HISTORIC AND DESIGN REVIEW COMMISSION

HDRC CASE NO: 2022-346
ADDRESS: 506 STIEREN
LEGAL DESCRIPTION: NCB 2966 (STIEREN STREET REPLAT), BLOCK 1 LOT 18
ZONING: RM-4, H
CITY COUNCIL DIST.: 1
DISTRICT: King William Historic District
APPLICANT: Caroline Gado
OWNER: APOLLO MAYORAL LLC
TYPE OF WORK: New construction of four, multi-story structures
APPLICATION RECEIVED: June 13, 2022
60-DAY REVIEW: Not applicable due to City Council Emergency Orders
CASE MANAGER: Rachel Rettaliata

REQUEST:

The applicant is requesting conceptual approval to construct four residential structures on the lot addressed 506 Stieren. The proposal includes three, 3-story structures and one, 2-story structure.

3 SITE PLAN
3/32" = 1'-0"

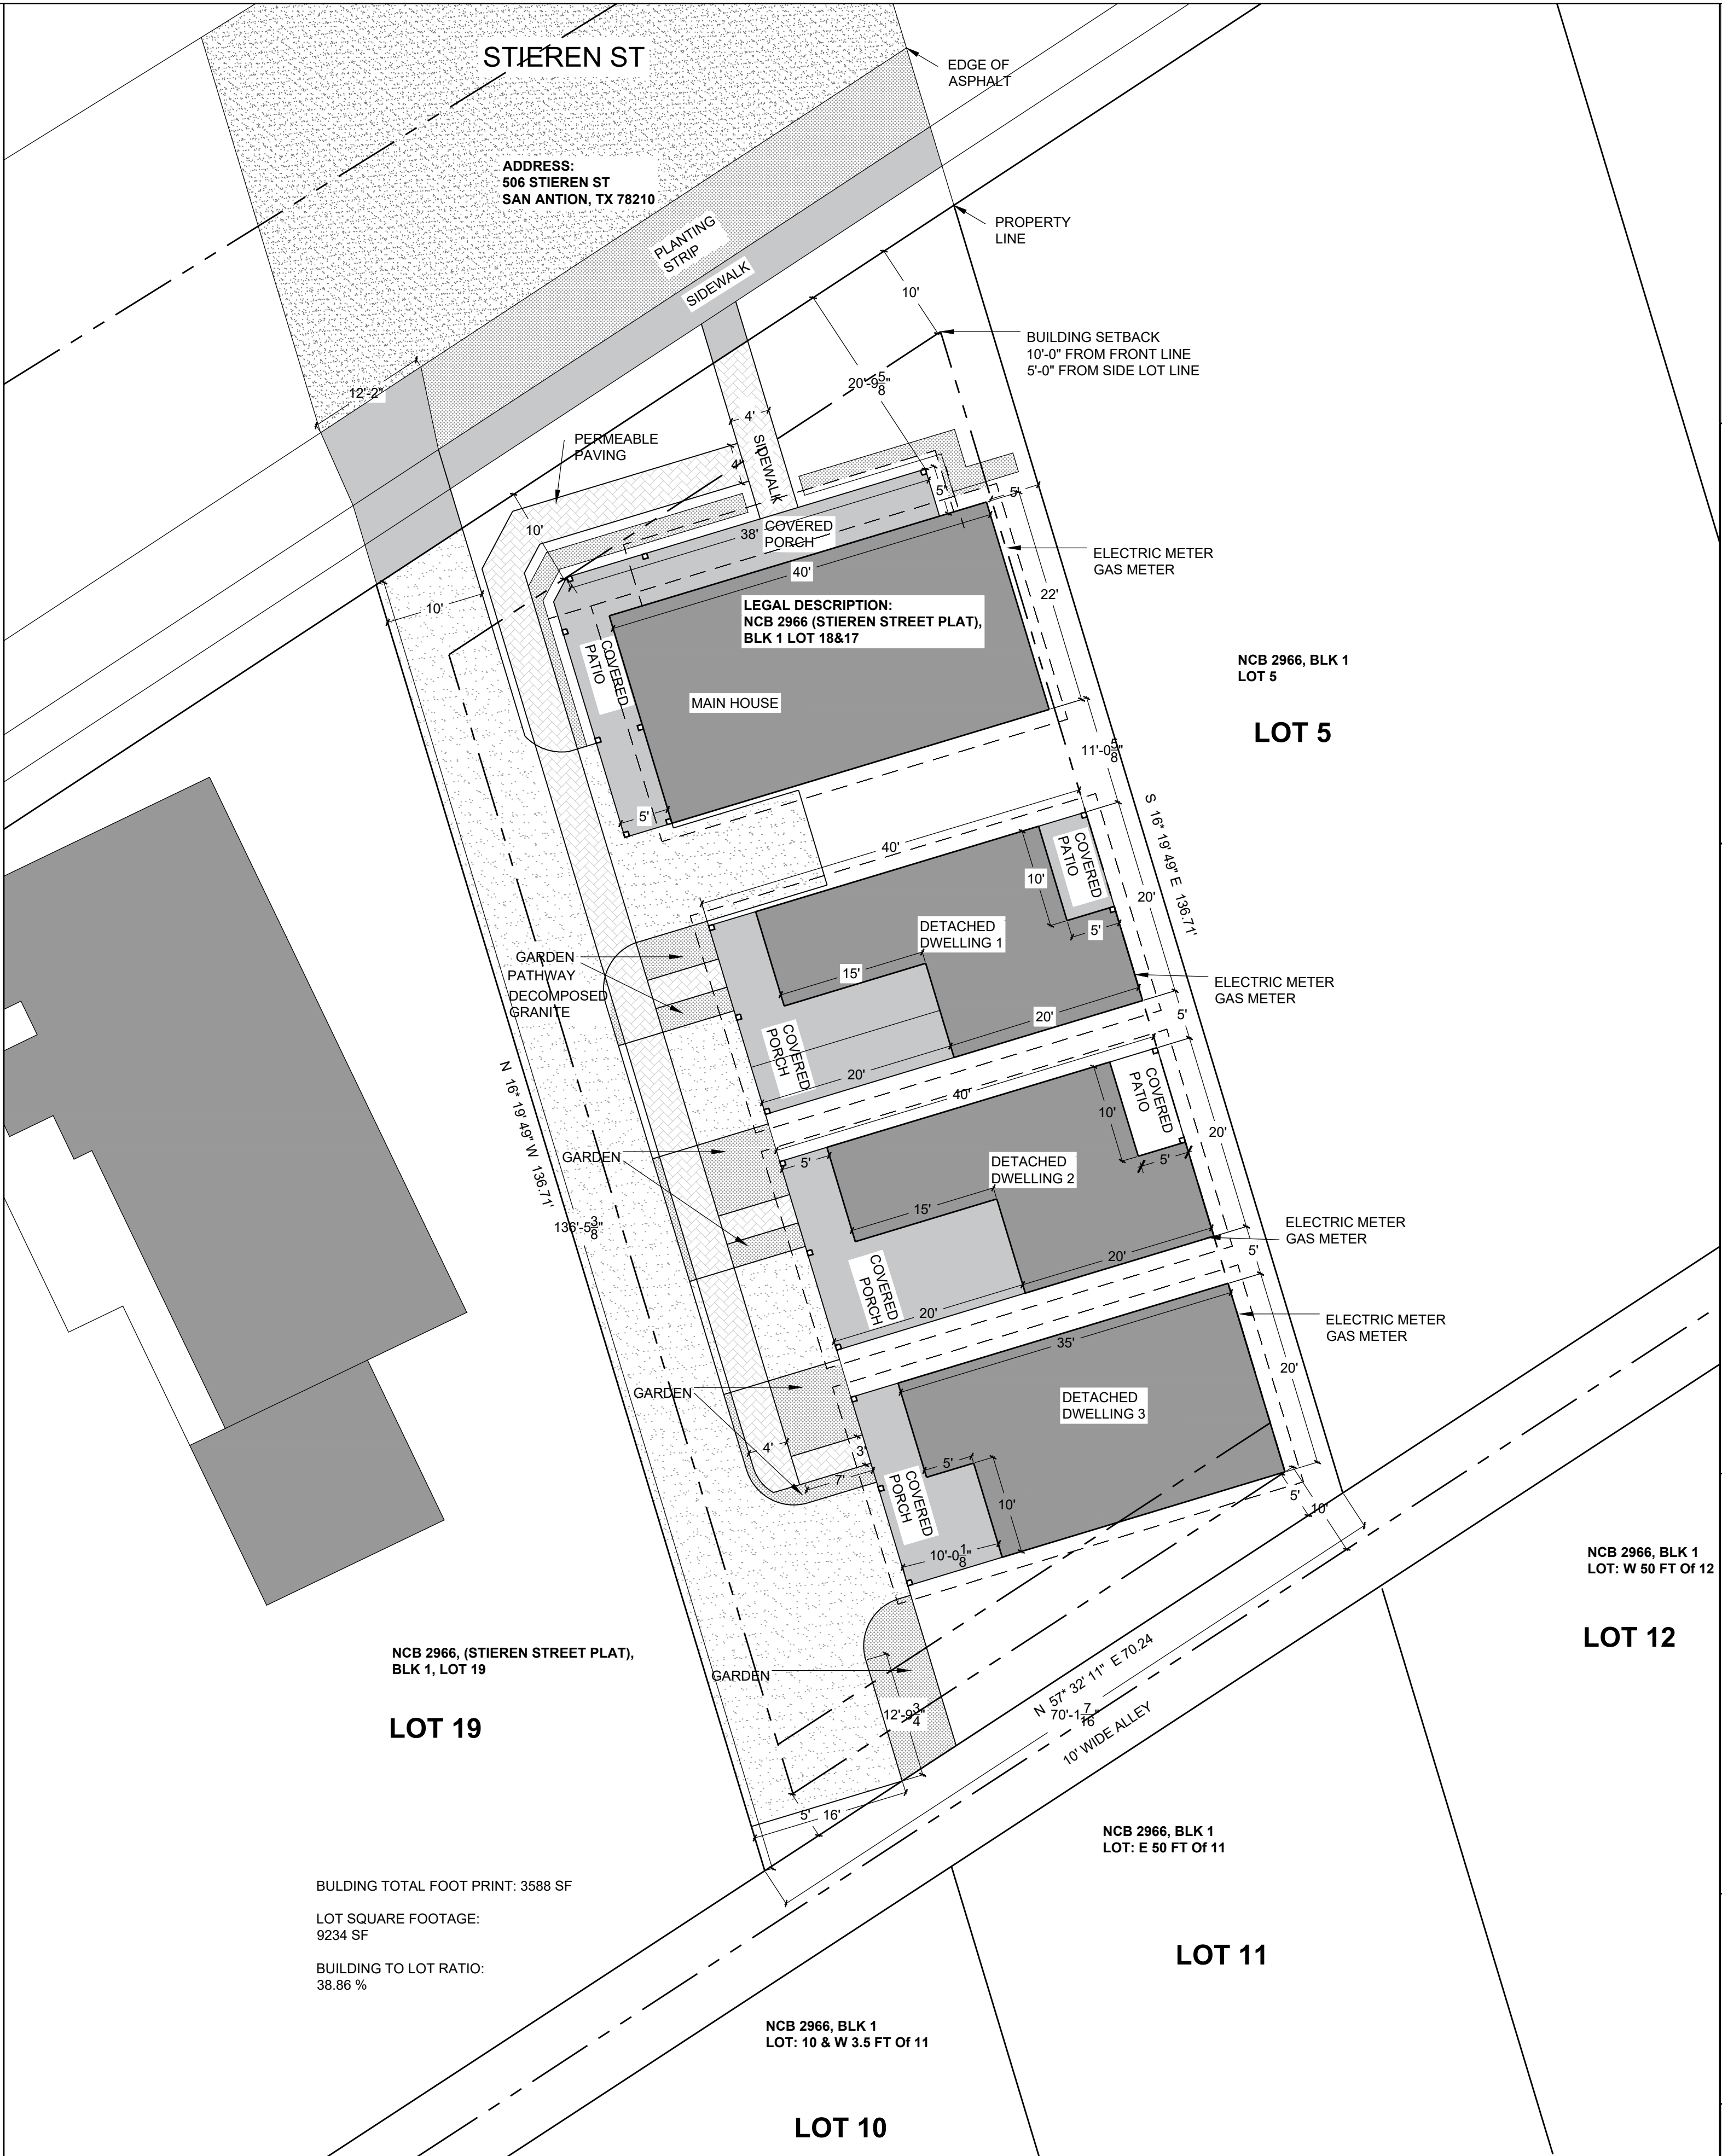
- f. FOOTPRINT – Per the submitted conceptual site plan, the front unit along Stieren will have the largest footprint of the four structures, with the three interior structures featuring a similar overall rectangular footprint. The documents include a lot coverage calculation for the building footprint, which states that the overall lot measures 9,234 square feet, the building footprints measure 3,588 square feet, for a building-to-lot ratio of 38.86%. According to the Historic Design Guidelines, new construction should respond to the existing development pattern of the district and buildings and impervious coverage should not exceed 50% of the lot. Historic lots in the district do not traditionally four detached structures. The predominant development pattern for residential lots is a larger primary structure and a smaller detached accessory structure in footprint. While the building footprints total less than 50% coverage of the lot, a calculation for total impervious cover is not provided. Staff does not find the proposed footprint consistent with the Guidelines. Staff finds that the applicant should explore a revised site configuration and building number that is more consistent with historic development patterns and lot coverage found in the neighborhood.

- l. **LOT COVERAGE** – According to the Historic Design Guidelines, new construction should be consistent with adjacent historic buildings in terms of the building to lot ratio. The building footprint for new construction should be limited to no more than 50 percent of the total lot area. The documents include a lot coverage calculation for the building footprint, which states that the overall lot measures 9,234 square feet, the building footprints measure 3,588 square feet, for a building-to-lot ratio of 38.86%. According to the Historic Design Guidelines, new construction should respond to the existing development pattern of the district and buildings and impervious coverage should not exceed 50% of the lot. The applicant has not provided a formal lot coverage percentage for buildings and impervious cover. Staff does not find the proposal consistent with the level of information provided at this time.

- m. **DRIVEWAY AND PARKING** – The applicant has proposed to install a shared common drive along the western edge of the property. The garages on all structures are located on the west elevations facing the side drive, embedded within the mass of the structure. Per the Guidelines, the predominant garage orientation found along the block should be matched. Do not introduce front-loaded garages or garages attached to the primary structure

on blocks where rear or alley-loaded garages were historically used. Staff finds the attached garage configuration inconsistent with the Guidelines. Staff finds that detached garages or parking areas should be utilized instead of attached garages in the primary structures.

- o. MECHANICAL EQUIPMENT – The applicant is required to comply with the Historic Design Guidelines related to equipment location and screening.
- p. LANDSCAPING AND HARDSCAPING – The applicant has provided staff with a site plan that indicates some conceptual landscaping and hardscaping proposals, including a decomposed granite driveway long the western edge of the property, a new 4' wide walkway from the primary right-of-way and connecting the structures along the side drive, small gardens, and shrubbery. Staff finds that the driveway width should be a maximum of 10' to be consistent with the Historic Design Guidelines for Site elements. Staff also finds that the applicant should increase landscaping and pervious cover where feasible.

- i. That the applicant explores a revised site configuration and building number that is more consistent with historic development patterns and lot coverage found in the neighborhood as noted in finding d, e, and k.

- vi. That detached garages or parking areas be utilized instead of attached garages as noted in finding l.
- vii. That the applicant modifies the proposed windows to be one over one and submits window specifications for final approval. Windows should be fully wood or aluminum clad wood and feature an inset of two (2) inches within facades and should feature profiles that are found historically within the immediate vicinity. White color is not allowed, and color selection should be presented to staff. Meeting rails must be no taller than 1.25" and stiles no wider than 2.25". There should be a minimum of two inches in depth between the front face of the window trim and the front face of the top window sash. This must be accomplished by recessing the window sufficiently within the opening or with the installation of additional window trim to add thickness. Window trim must feature traditional dimensions and an architecturally appropriate sill detail. Window track components must be painted to match the window trim or be concealed by a wood window screen set within the opening.

- viii. That the applicant reduces the proposed impervious coverage to be introduced by the proposed buildings and hardscaping where feasible.
- ix. That the applicant submits a comprehensive landscaping plan for final approval. The landscaping plan should indicate all setbacks with dimensions, all locations and dimensions of proposed hardscaping, and the locations and species of plants. The applicant should indicate all mechanical equipment on the site plans and/or elevations for final approval.
